# Certificate of Appropriateness

### **830 N. 24<sup>th</sup> Street, West Avenues West Historic District**

## Date issued 11/12/2025

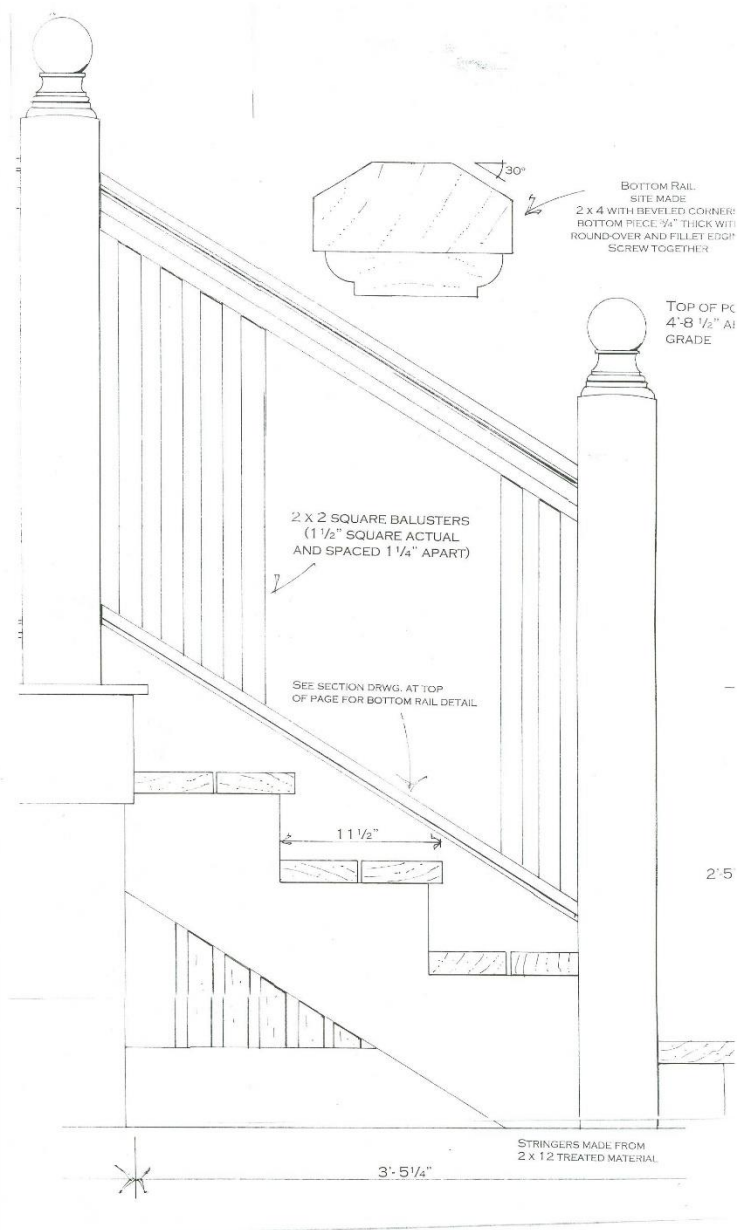
Upper porch to receive new EPDM roof and new rails/balusters

New porch rails will be molded and baluster spacing to match the design above
